**Medway Planning & Economic Development Board
Meeting**

Evergreen Village

UPDATED

Field Changes

POLE LAMP (TYP)
N.T.S.

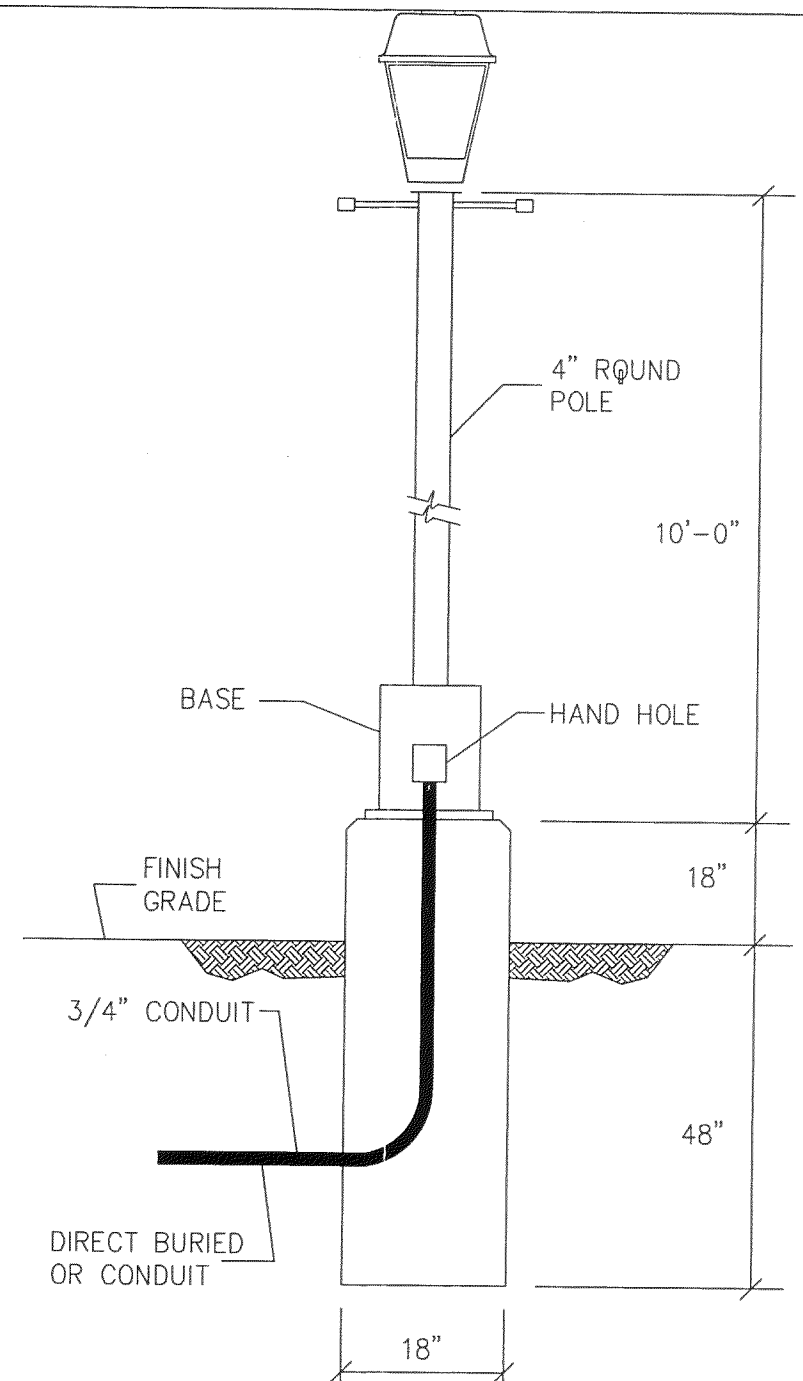
Suzy, After reviewing the light posts with the lighting expert at Fergusons, she indicated that the proposed post lights are for a commercial application and would be too bright given the lumens output. She indicated that type of light is typically seen on much taller posts for street lighting or parking lots. Given that there is a street pole light at entrance to subdivision and parking lights from abutting property as well as 2 lights over each garage door and the front door, any more lighting might be excessive.

The only other recommendation if the planning board wanted to keep the post lights would be to make them dark sky lights at the proposed location at the end of the walkway which is what is commonly used.

I would like to propose removing the light posts or at the very least modify them to residential post lights.

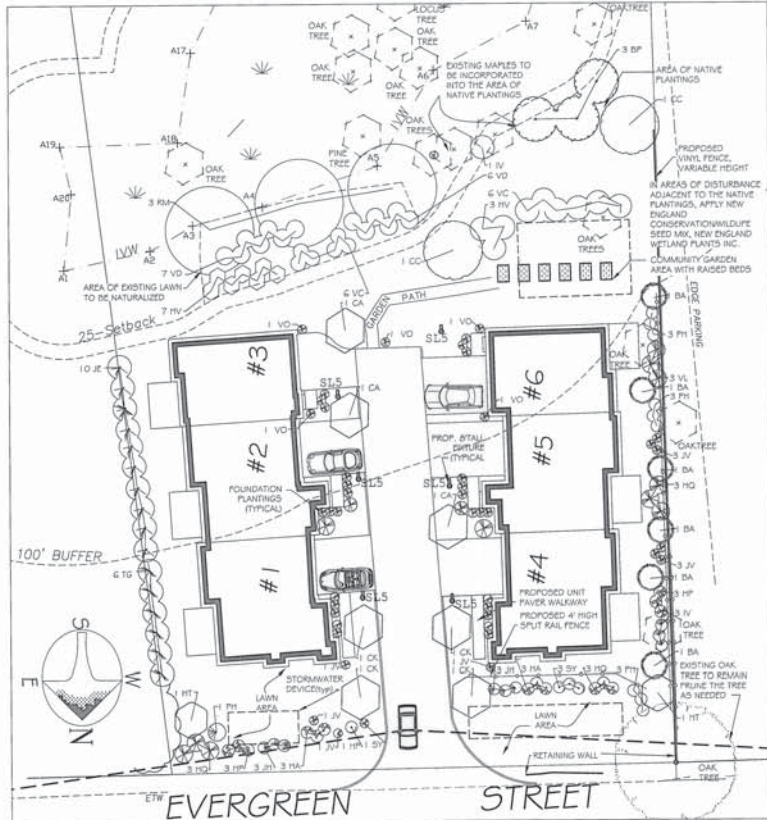
Also, not sure who I need to discuss the front stone wall with. Now that the grade has been reduced (per Officer Watson's request for sight line visibility) there really isn't as long an area where we can do much of a wall. We can start by the tree where the old wall is but then it tapers down pretty quickly to an area that is almost flat to the street right about where the transformer box is. I would like to review this with the right person before having the wall built. If we bring fill back in, it defeats the purpose of reducing the grade. Please advise.

retaining wall would serve little purpose, other than for aesthetics, as current grades appear to gradually transition to Evergreen Street. The Applicant should coordinate with PEDB and Medway Design Review Committee (DRC) to determine if the proposed retaining wall should be constructed.
